SERVICE INSTRUCTION

Introduction of sodium filled exhaust valves and new cylinder heads for ROTAX® Aircraft Engine types 912 and 912 i (Series)

ATA System: 72-20-00 Cylinder head

Fig. 3

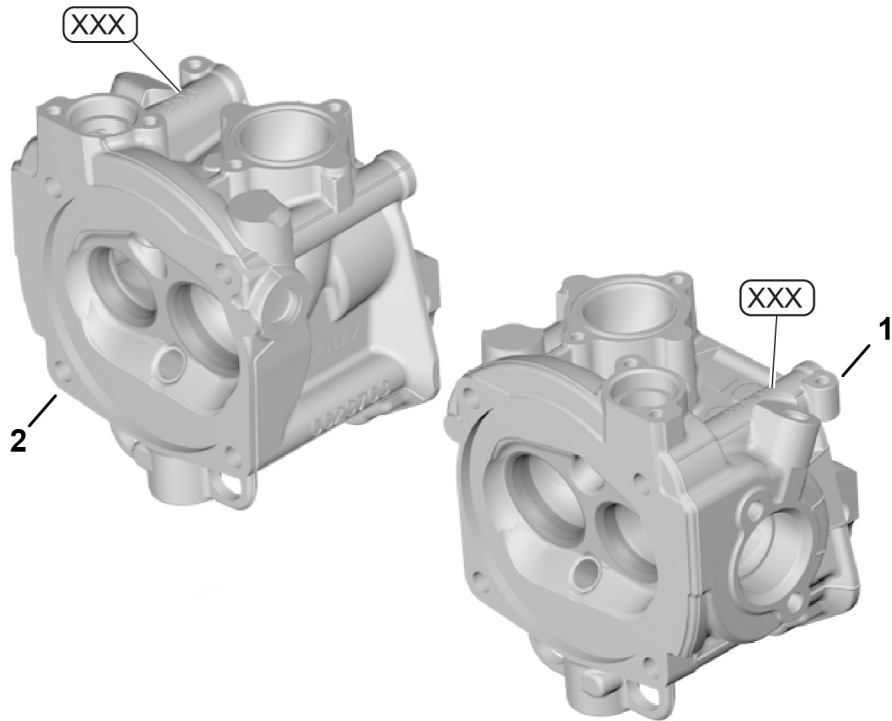
NOTE: XXX - Location of part number.

Fig. 4

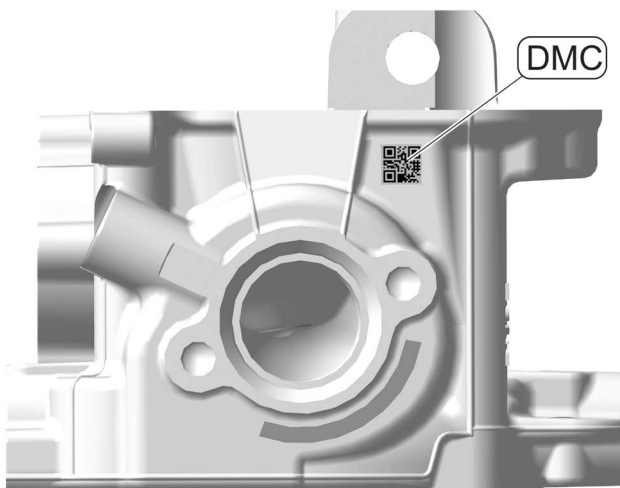
NOTE: DMC - Data Matrix Code
All the cylinder heads are marked with DMC, a two-dimensional code containing information encoded as text and/or numeric data, that allow the component traceability verification.
